SUBJECT: Request for Additional Information Regarding
Extended Power Uprate
Grand Gulf Nuclear Station, Unit 1
Docket No. 50-416
License No. NPF-29

Grand Gulf Nuclear Station Extended Power Uprate

Response to Request for Additional Information

Mechanical and Civil Engineering Branch, Steam Dryer (Non-Proprietary)

Figure 2-2: GGNS SRV Branch Line Configuration

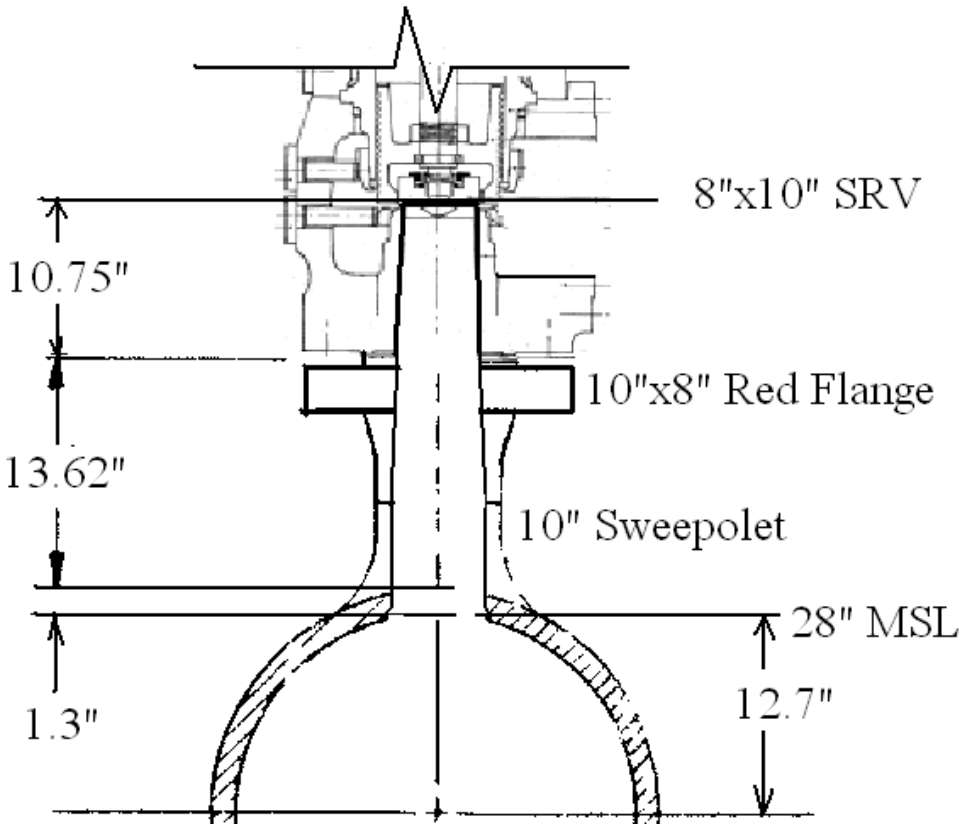
In response to RAI 9, the licensee stated that four safety relief valves (SRVs) will be instrumented and monitored to maintain acceleration levels within the acceptance limits. Please explain how the licensee will ensure that the valve with the maximum vibration level will be among those that are selected for vibration monitoring. Also, please provide the plan for mitigating excessive vibration (should it occur) and/or replacing valves with designs that are more resistant to the vibrations.

Another alternative would be to shorten the SRV branch connection and thus increase the branch fundamental acoustic resonance frequency. This would result in the Strouhal number ((branch frequency)*(branch diameter) / (MSL velocity)) at EPU being equal to or higher than the Strouhal number at CLTP where excessive valve vibration has not been observed. The steam line velocity at CLTP is approximately [[
]] (See EPU LAR, Attachment 11, Appendix A). Figure 2-2 depicts the existing GGNS SRV branch geometry. It would be possible to replace the reducing flange with a design that would reduce the branch length by approximately 3.5 inches and increase the branch line resonance enough to offset the increase in velocity.

Figure 4-1 Schematics of a Vane Assembly

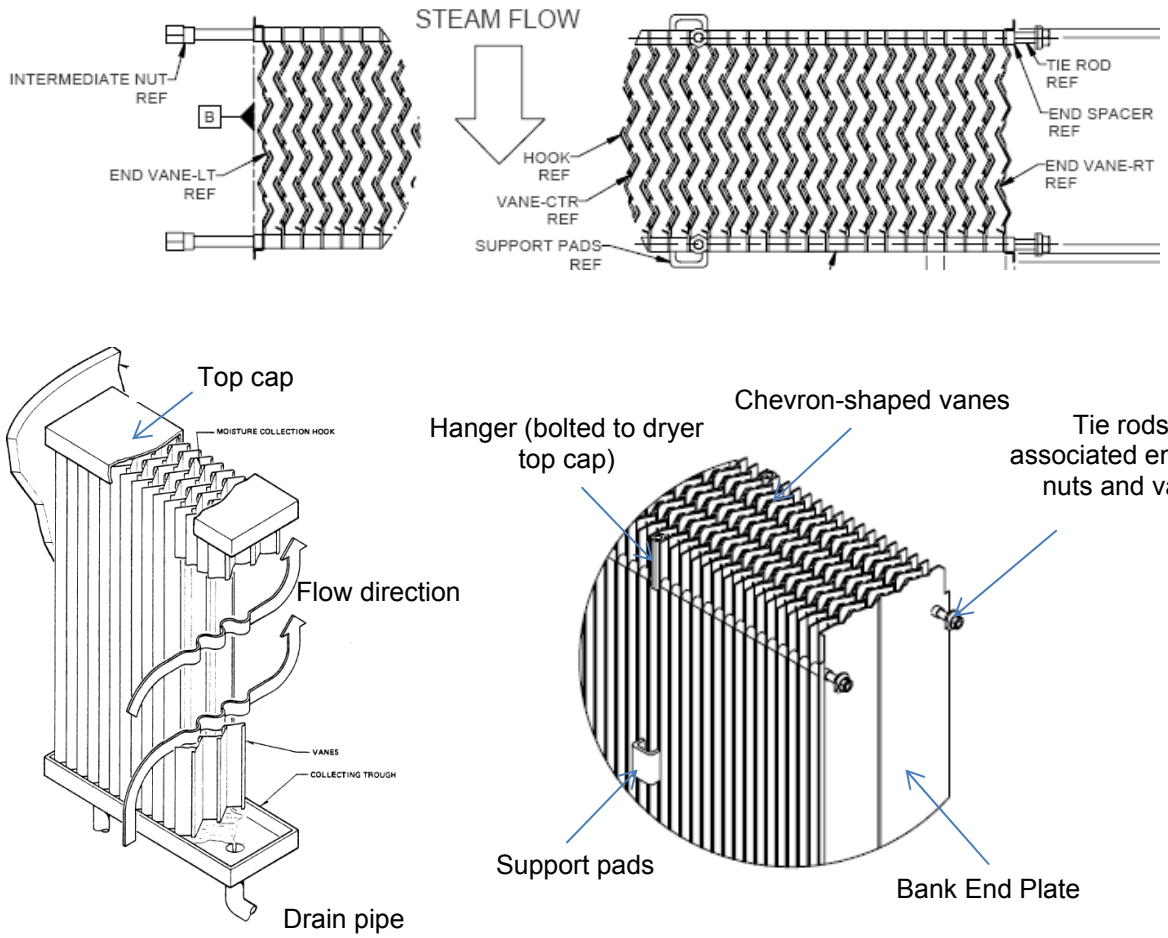
(a) In response to RAI 13, the licensee stated that, [[

]] Please explain

why [[
]] Also, please explain whether the vane assemblies can experience fatigue failure due to FIV loading and generate loose parts. Please provide information on the magnitude of the fundamental frequency of the vane assembly substructure.

a) The purpose of the chevron-shaped dryer vanes is to remove the moisture from steam. The vane assemblies are housed within the dryer hoods. They are contained within the bank end plates, the top cap, the bank trough, and the inlet and outlet perforated plates. The individual tie rod sections holding the vane plates and spacers in place are 4½ - 5 feet long and joined together with intermediate fittings to form continuous rods that run the entire length of the dryer bank. The tie rod end nuts are then welded to the bank end plates, capturing the tie rods, vane plates, and spacers. The chevron-shaped vanes and their associated tie rods are shown in Figure 4-1. [[
]] The "stacked plate" assembly of the vanes and spacers on the tie rods rest in the bank trough. This configuration has a large number of [[
]]

The vane assemblies represent a significant part of the overall dryer mass [[
]] and their structural interaction with the dryer has been modeled. [[
